## PLANNING TECHNICAL REVIEW COMMITTEE –AGENDA

## PLAN SNAPSHOT REPORT WAIV-2023-0006 FOR CITY OF DOVER, N.H.

**RE: Second Street Courthouse – Site Plan Amendment  
10 Second Street  
Dover Planning File: P21-30**

**TO:** Donna Benton, Planner, City of Dover      **DATE:** 6/8/2023  
**FROM:** Neil J. Rapoza, PE  
CIVIL CONSULTANTS  
**SUBJECT:** Plan Revision Memo  
**PROJECT:** 20-279.00 One First Street, LLC (Dover project #P21-30)

**PROPOSED FIRST STREET UTILITY PLAN**

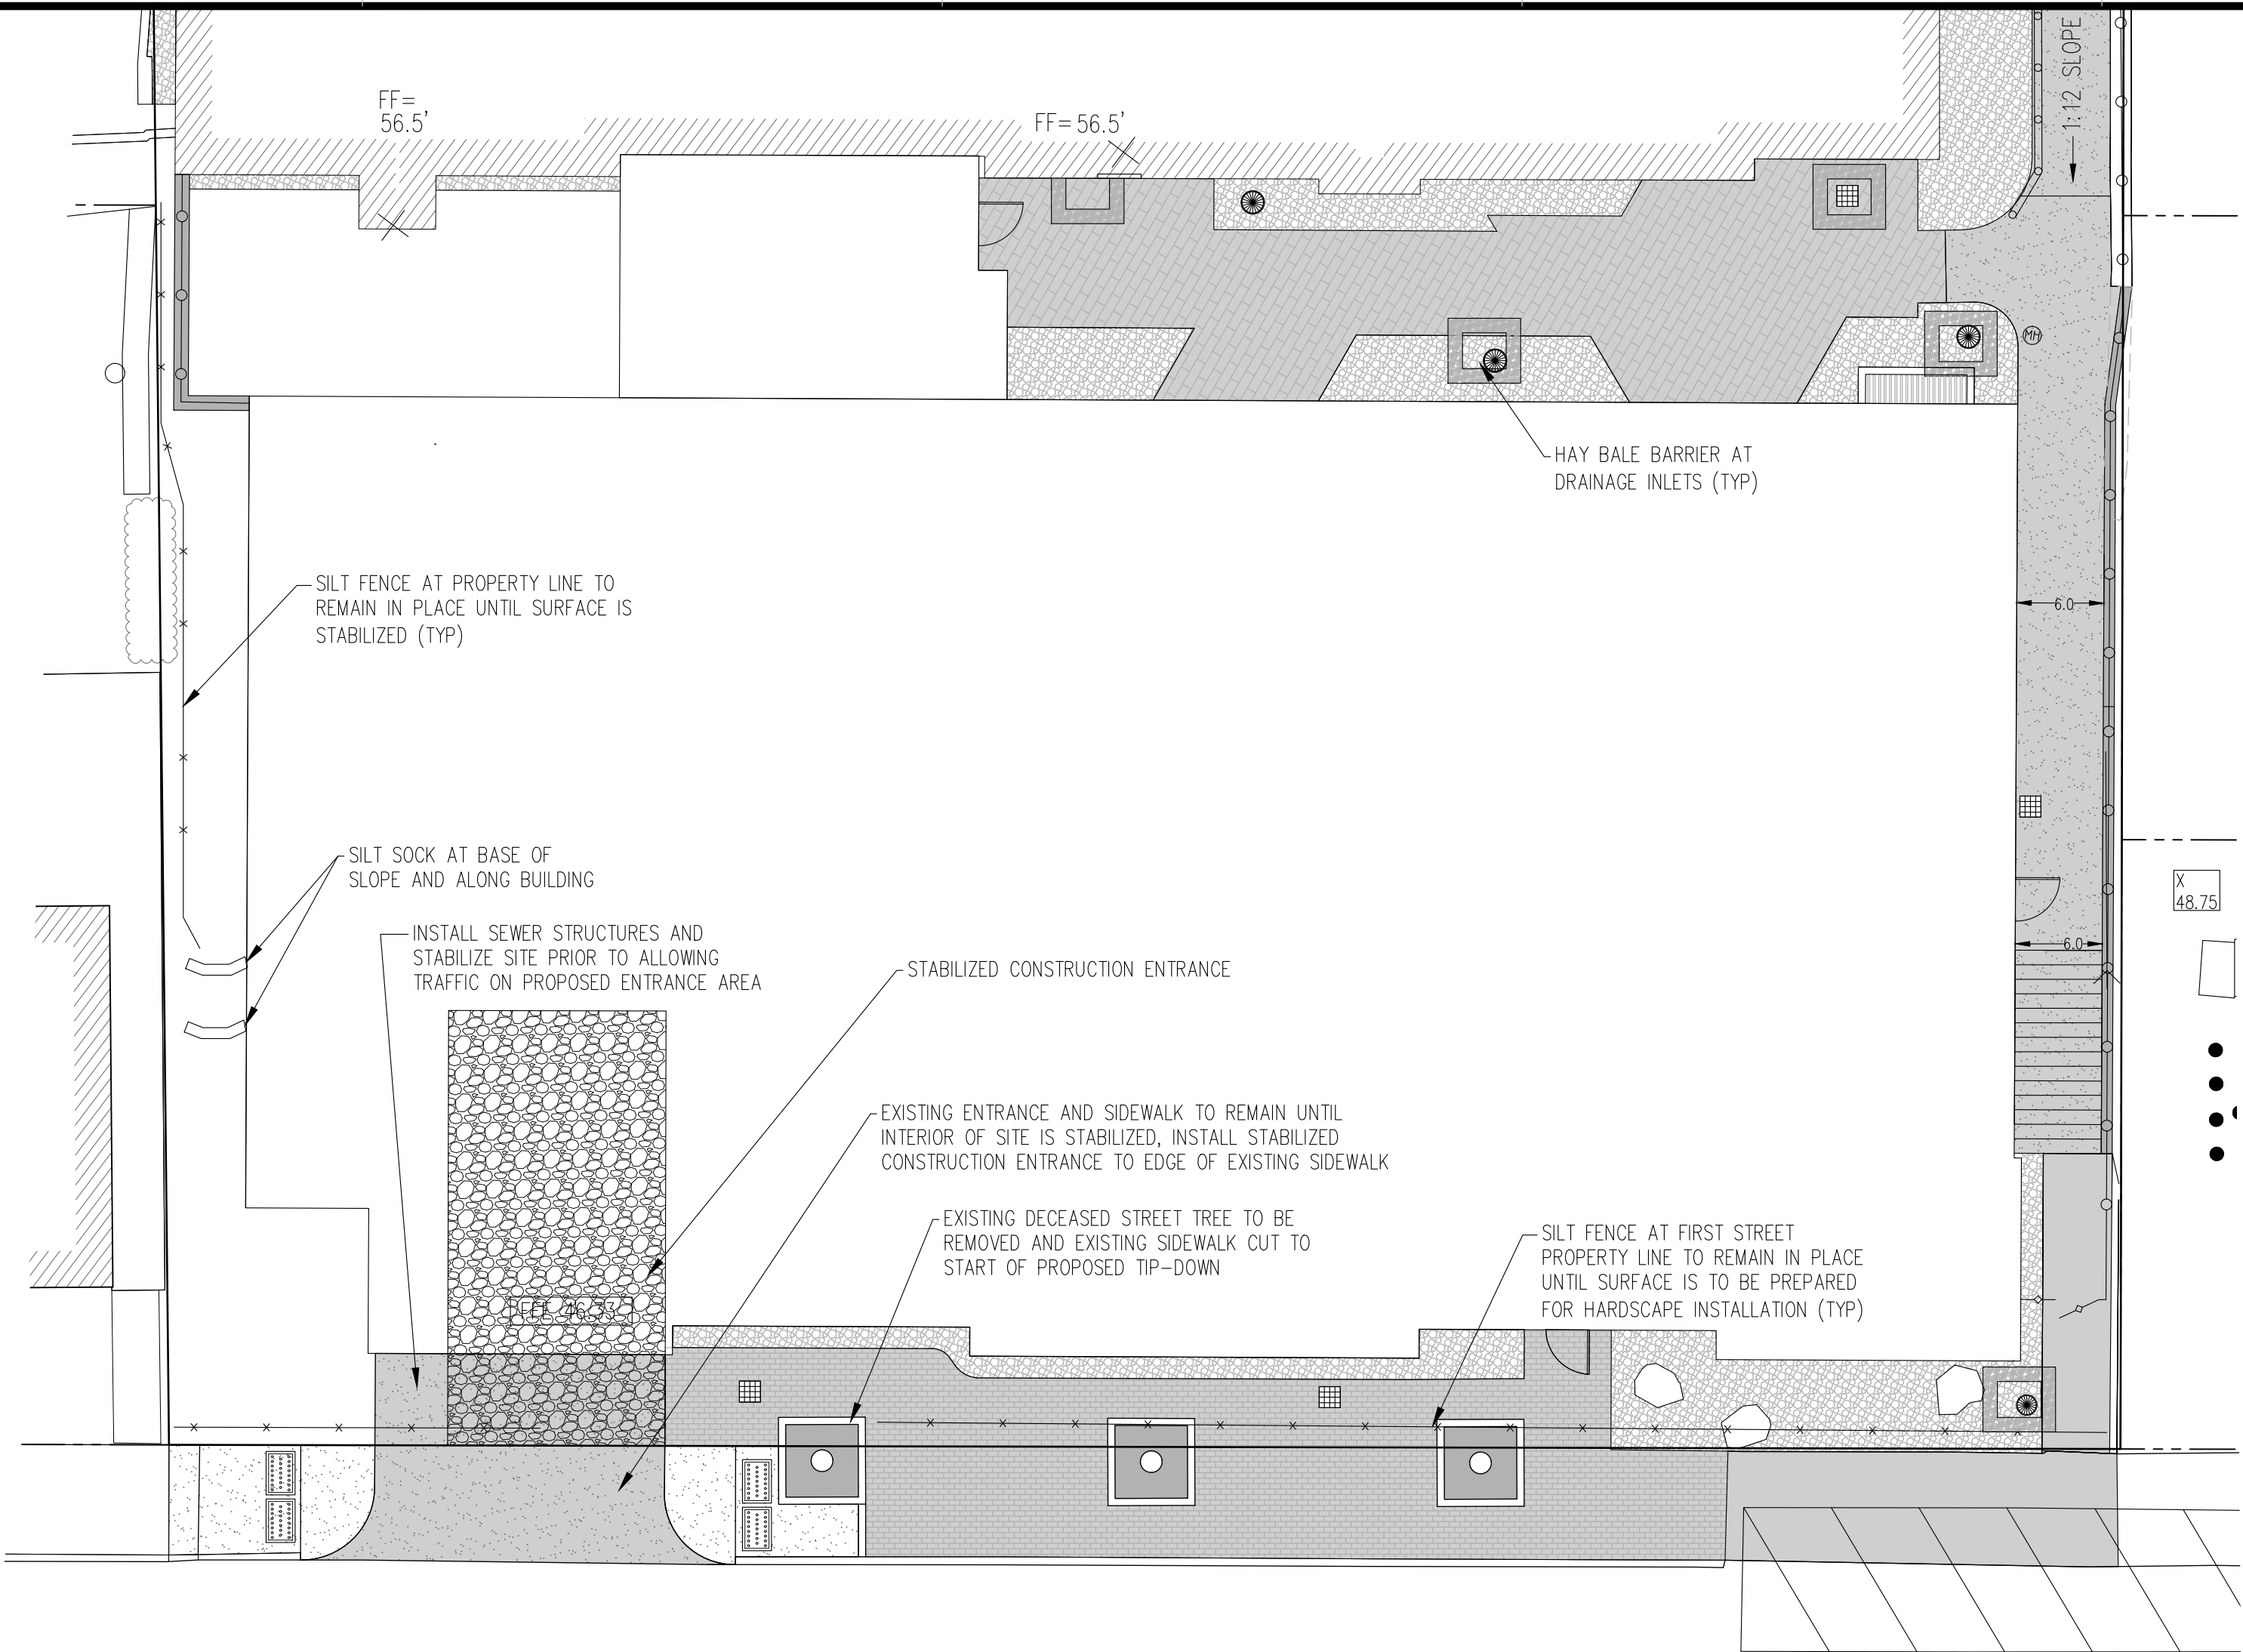
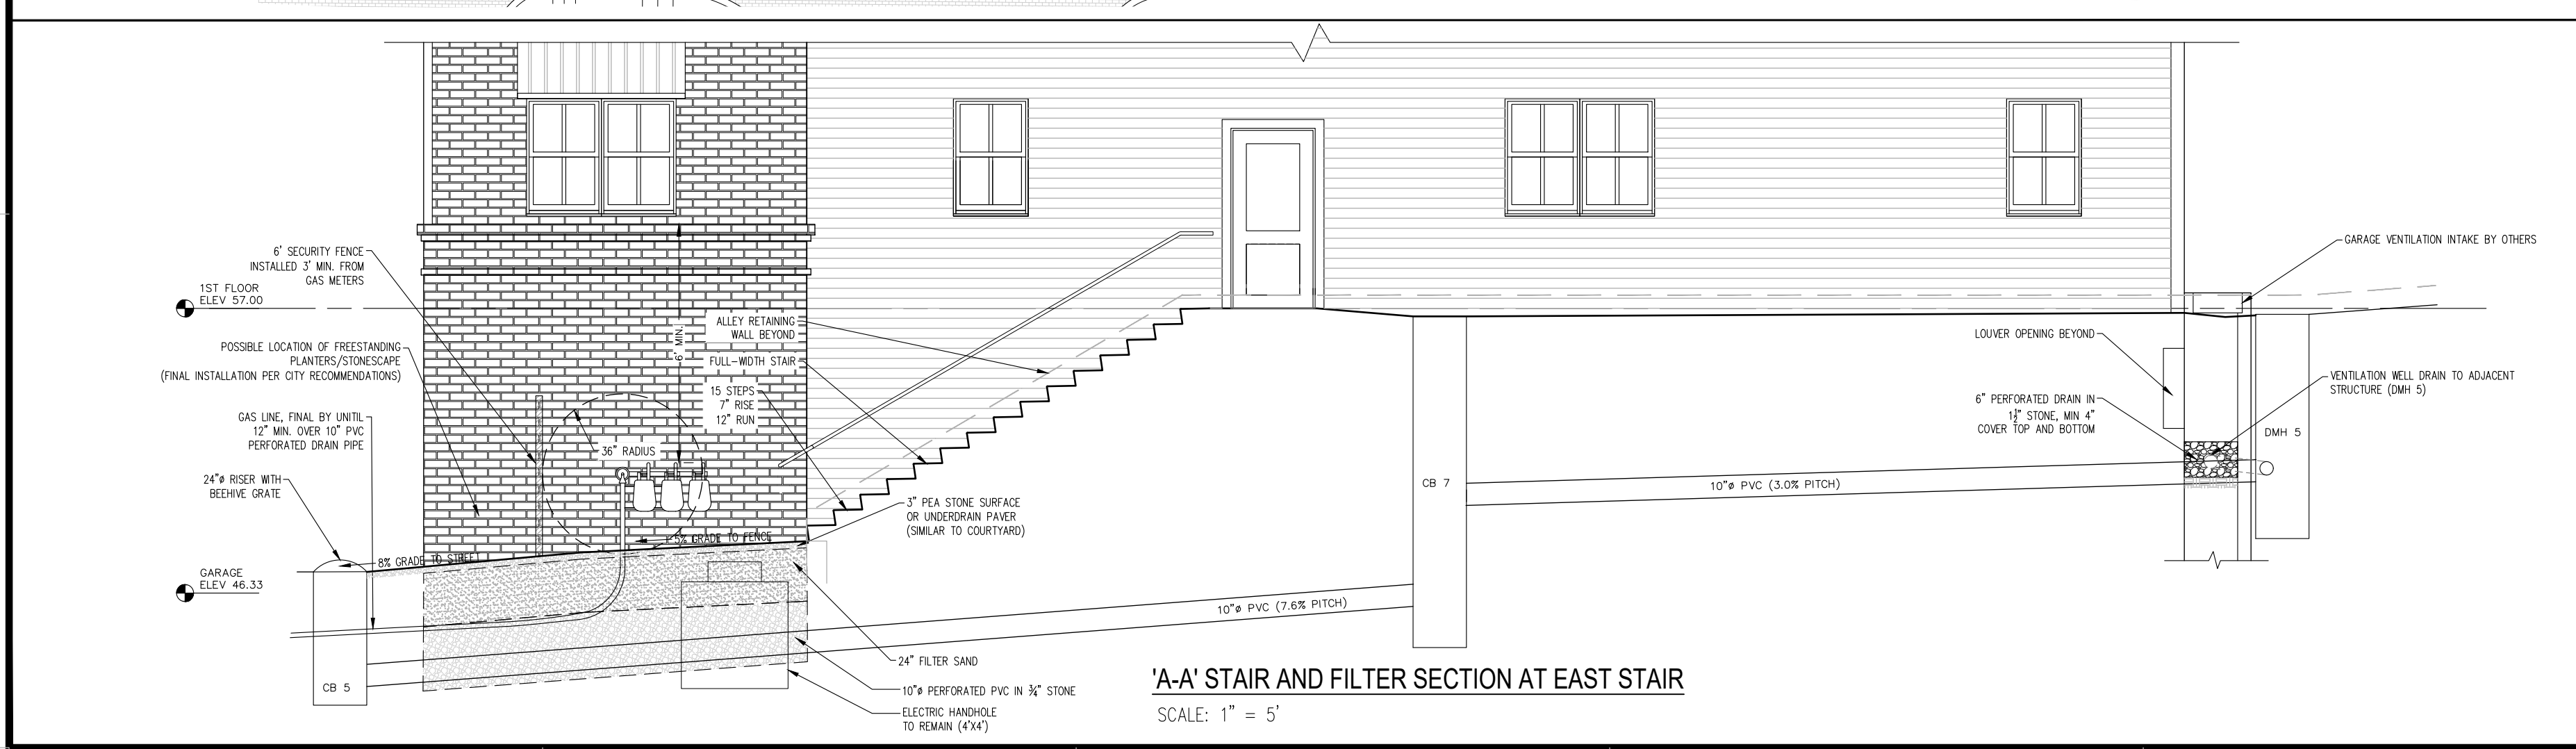
#### Sheet L5

- a. Revised stair and planter configuration at east alley to accommodate existing utilities encroaching on subject lot.
- b. Added construction details for east alley stair with associated fence and rails.
- c. Revised transformer pad per Eversource request.
- d. Relocated gas meters per Unitil request.
- e. Revised utility layout at First Street per existing conditions upon excavation of area.
- f. Added electric meter and associated worker platform.
